DRAINAGE CONFORMANCE LETTER
FOR
WALDEN SANITATION DISTRICT WWTP
3155 WALKER ROAD, EL PASO COUNTY, COLORADO
PART OF WALDEN PRESERVE 2 – FILING NO. 5

NOVEMBER 2025
REVISED MARCH 2026

PCD FILE PPR2538

PROJECT: WALDEN CORPORATION WWTP 3155 WALKER ROAD COLORADO SPRINGS EL PASO COUNTY, COLORADO	SHEET TITLE: SITE DEVELOPMENT PLAN	
ENGINEER: AQUAWORKS DBO, INC. 3252 WILLIAMS STREET DENVER, COLORADO 80205 (303) 477-5915	PROJECT NUMBER: PCD FILE PPR2538	SCALE: 1"=100'
		SHEET: C1.1

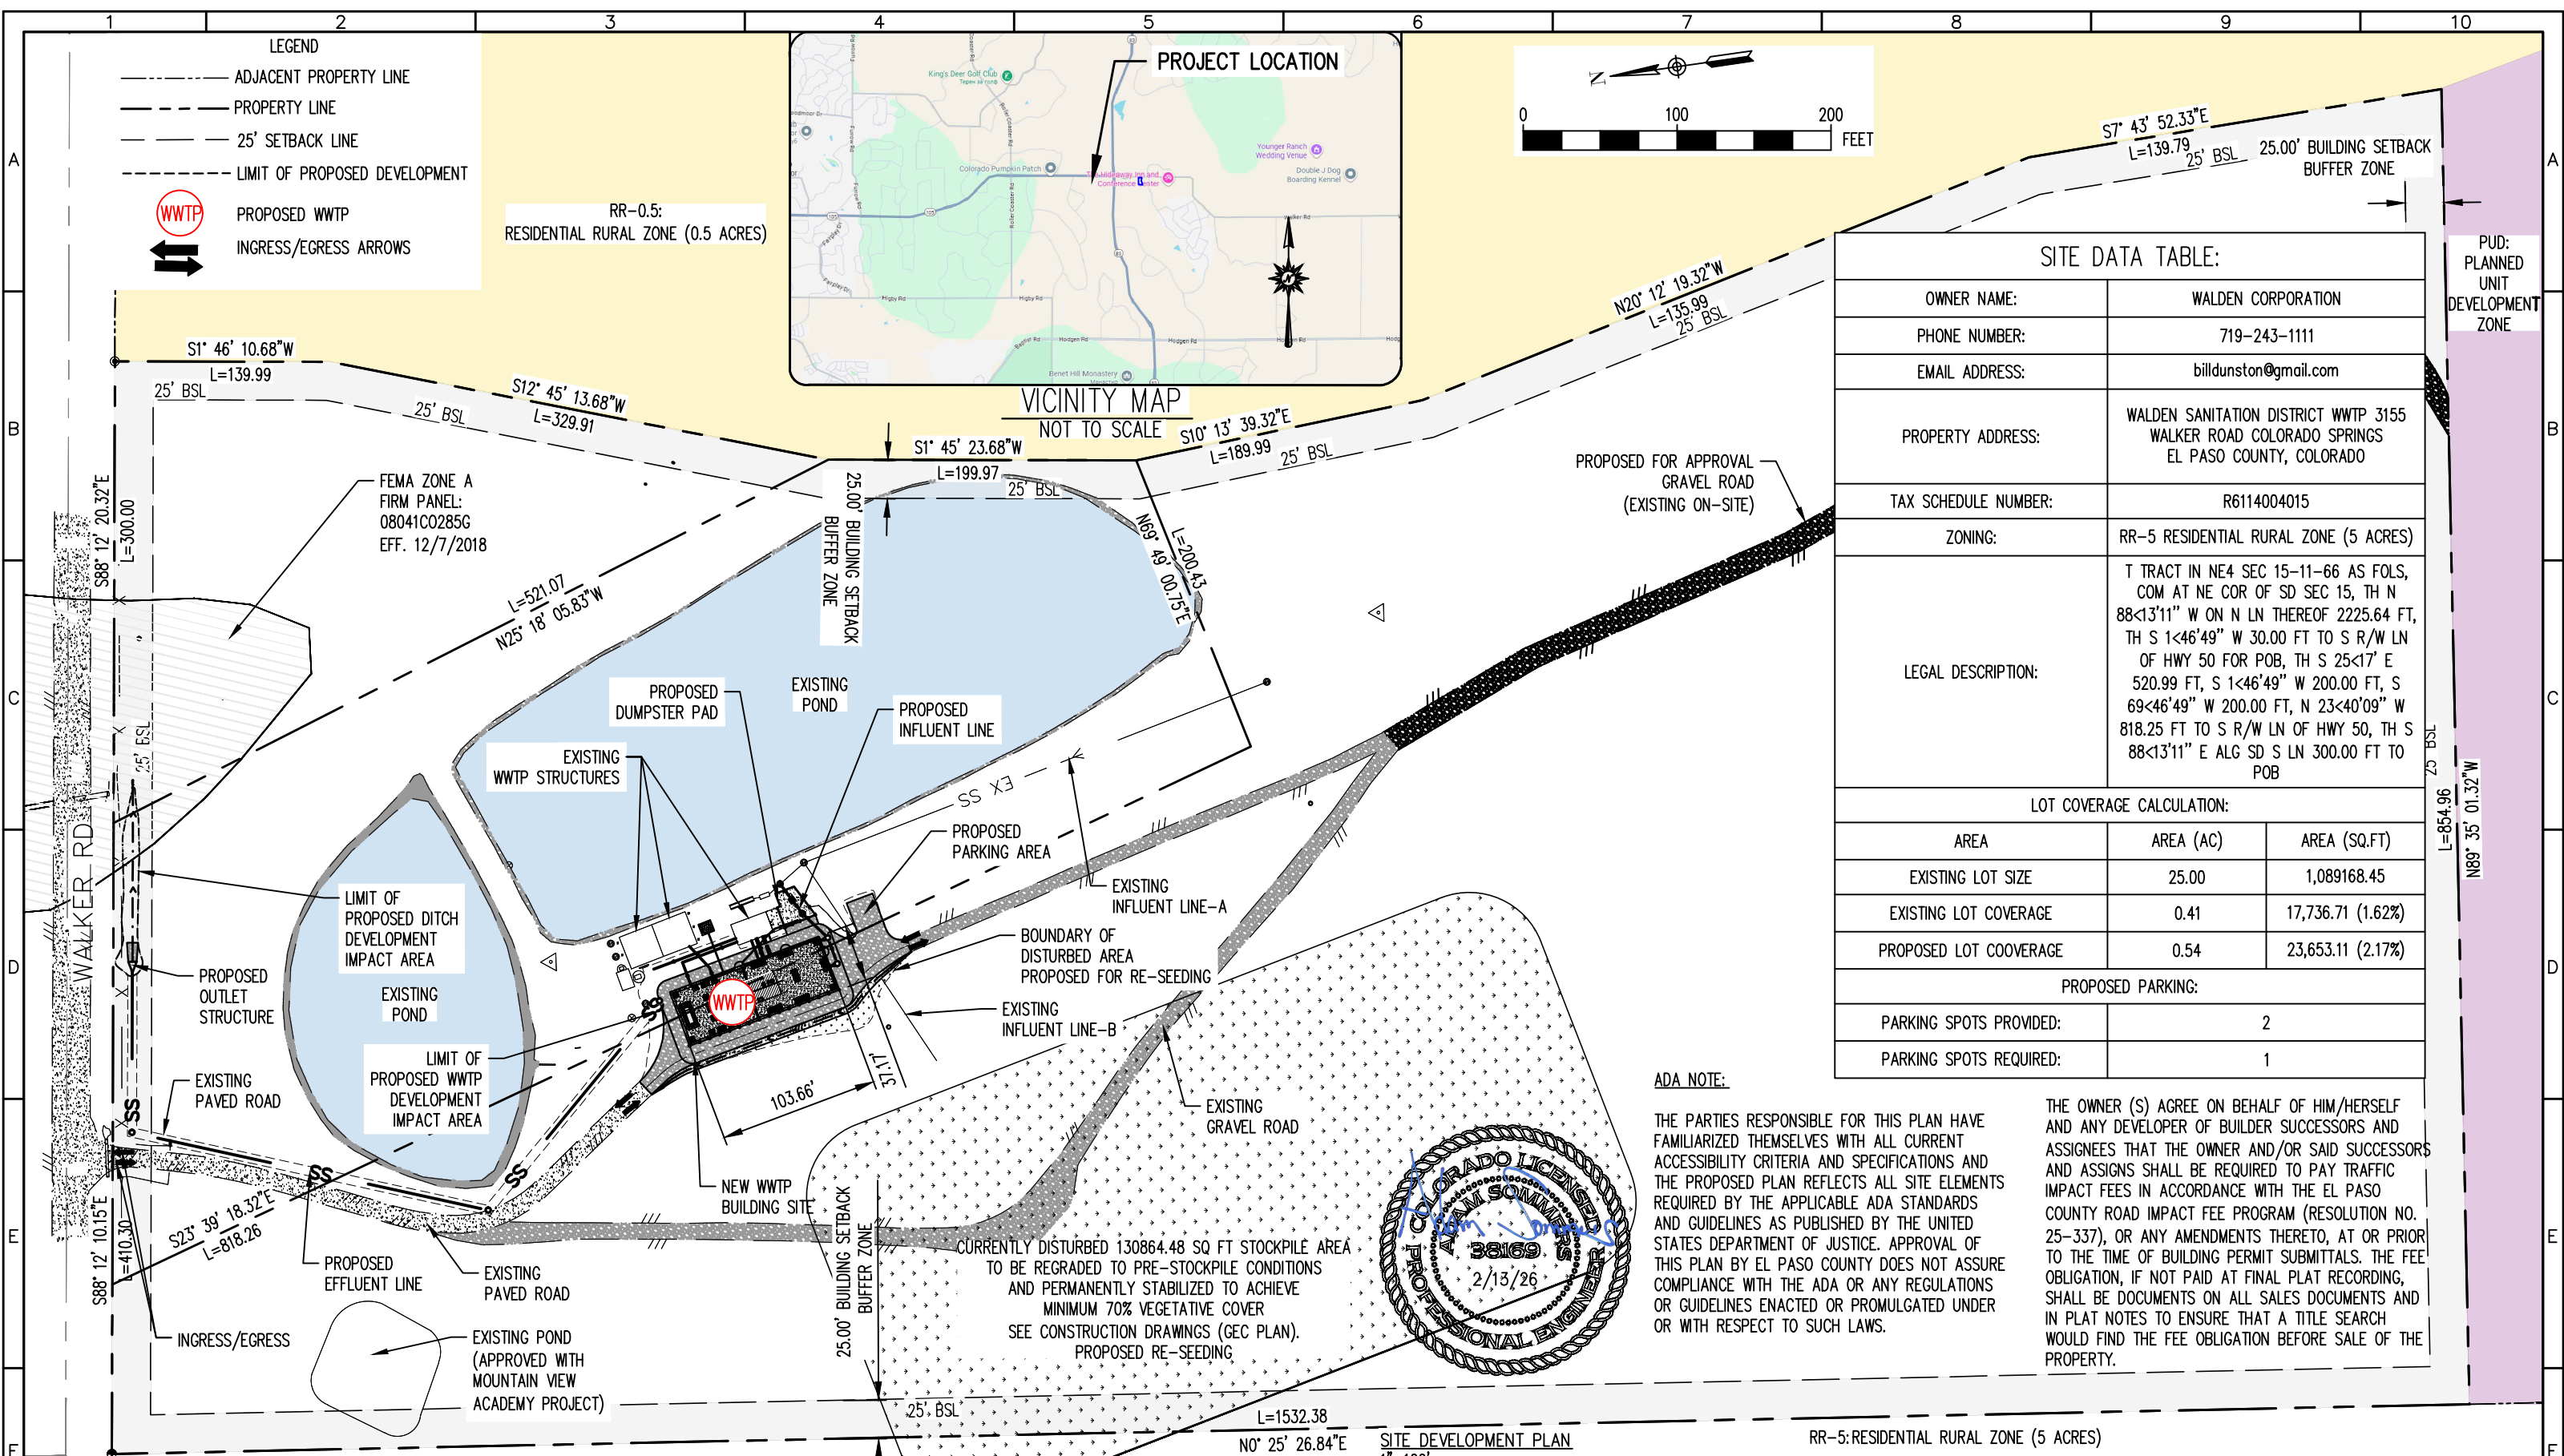
Site development plan shows drain pipes taking flows from these basins north. please revise.

Site development plan shows drain pipes taking flows from these basins north. please revise.

Site development plan shows pipes that will carry the flows from the pond basins to the north.

View Academy Development (PCD Project No. [redacted]). The four on-site sub-basins are described as follows: **Basin descriptions have been revised** ct.
